Number: TSB-FC-2015-023

Symptom: Clean water leaking from machine when solution system is not activated or when machine is off. Various machines

Date: 7th July, 2015

Fig.1

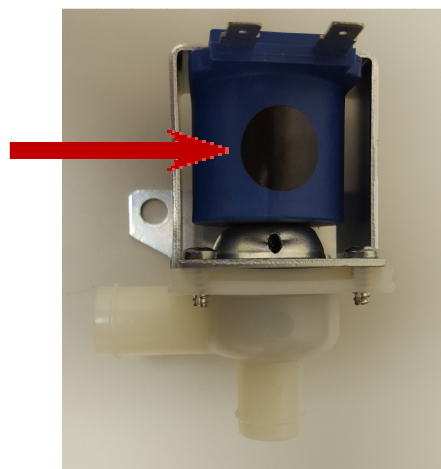
A new solenoid valve with a heavier spring has been implemented in production to prevent leakage. The new valves can be identified by the black sticker on the coil. — See page 2, Fig.1

Black sticker on new coils

FIELD CORRECTIVE ACTIONS: Replace leaking solenoid; see below to identify part number.
